PCN# 20130909003
Carrier Tape Material change for LM3530UMX Device
Information Only

PCN Number:	20130909003			PCN Date:	09/13/2013								
Title:	Carrier Tape Packing Material change for LM3530UMX Device												
Customer Contact:	PCN Manager	Phone:	+1(214) 480-6037	Dept:	Quality Services								
Change Type:													
<input type="checkbox"/>	Assembly Site	<input type="checkbox"/>	Assembly Process	<input type="checkbox"/>	Assembly Materials								
<input type="checkbox"/>	Design	<input type="checkbox"/>	Electrical Specification	<input type="checkbox"/>	Mechanical Specification								
<input type="checkbox"/>	Test Site	<input checked="" type="checkbox"/>	Packing/Shipping/Labeling	<input type="checkbox"/>	Test Process								
<input type="checkbox"/>	Wafer Bump Site	<input type="checkbox"/>	Wafer Bump Material	<input type="checkbox"/>	Wafer Bump Process								
<input type="checkbox"/>	Wafer Fab Site	<input type="checkbox"/>	Wafer Fab Materials	<input type="checkbox"/>	Wafer Fab Process

Appendix A Carrier Tape "From/To" Detail

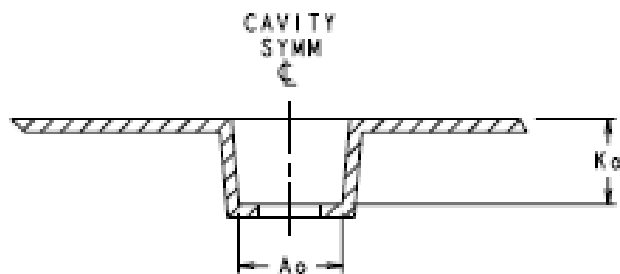
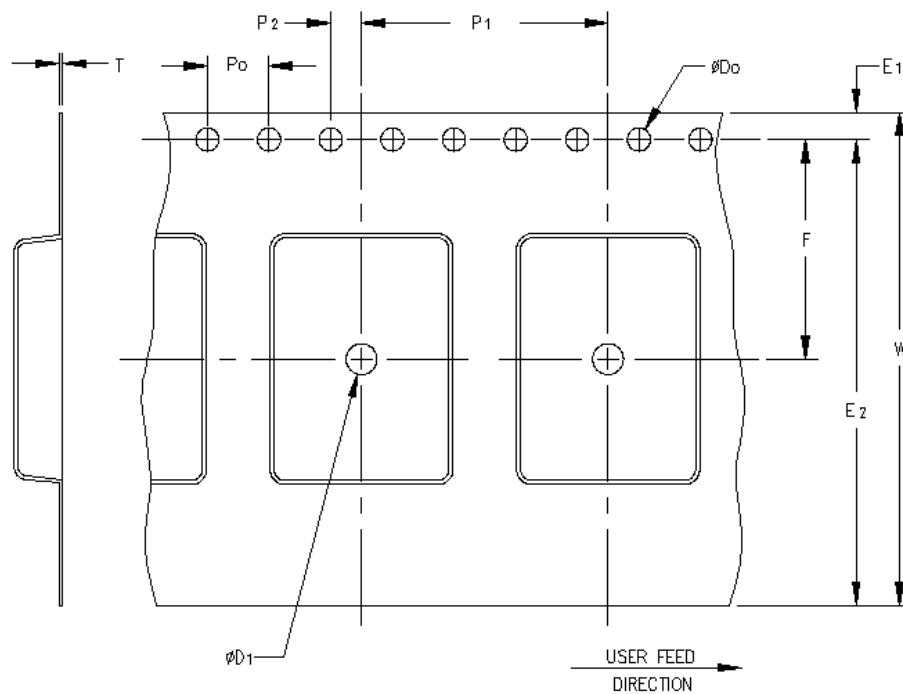
PCN Details													
Description of Change:													
Carrier Tape Material change for LM3530UMX Device. Pack material differences are shown below:													
<table border="1" style="width: 100%; border-collapse: collapse;"> <thead> <tr style="background-color: #92d050;"> <th style="text-align: center;">Pack BOM</th> <th style="text-align: center;">Current material</th> <th style="text-align: center;">Proposed material</th> </tr> </thead> <tbody> <tr> <td style="text-align: center;">Tape</td> <td>8097067-0001 Ao: 1.35 +/-0.05mm Bo: 1.65+/-0.05mm</td> <td>4212589-0014 Ao: 1.37 +/-0.05mm Bo: 1.77+/-0.05mm</td> </tr> </tbody> </table>						Pack BOM	Current material	Proposed material	Tape	8097067-0001 Ao: 1.35 +/-0.05mm Bo: 1.65+/-0.05mm	4212589-0014 Ao: 1.37 +/-0.05mm Bo: 1.77+/-0.05mm		
Pack BOM	Current material	Proposed material											
Tape	8097067-0001 Ao: 1.35 +/-0.05mm Bo: 1.65+/-0.05mm	4212589-0014 Ao: 1.37 +/-0.05mm Bo: 1.77+/-0.05mm

(See Appendix A for Tape "From/To" Detail)													
Reason for Change:													
Existing carrier tape 8097067-0001 causing LM3530UMX device to be stuck in the carrier tape pocket during SMT pick and place process.													
Anticipated impact on Fit, Form, Function, Quality or Reliability (positive / negative):													
None													
Changes to product identification resulting from this PCN:													
None													
Product Affected:													
<table border="1" style="width: 100%; border-collapse: collapse;"> <tbody> <tr> <td style="width: 50%;">LM3530UME-40/NOPB</td> <td style="width: 50%;">LM3530UMX-25A/NOPB</td> </tr> <tr> <td>LM3530UMX-40/NOPB</td> <td>LM3530UMX-40B/NOPB</td> </tr> <tr> <td>LM3530UME-25A/NOPB</td> <td>LM3530UMX-25A/S7002914</td> </tr> <tr> <td>LM3530UME-40B/NOPB</td> <td>LM3530UMX-25A/S7003079</td> </tr> </tbody> </table>						LM3530UME-40/NOPB	LM3530UMX-25A/NOPB	LM3530UMX-40/NOPB	LM3530UMX-40B/NOPB	LM3530UME-25A/NOPB	LM3530UMX-25A/S7002914	LM3530UME-40B/NOPB	LM3530UMX-25A/S7003079

A_0	1.37 ± 0.05
B_0	1.77 ± 0.05
K_0	0.56 ± 0.05
F	3.50 ± 0.1
P_1	4.00 ± 0.1
W	8.00 ± 0.3
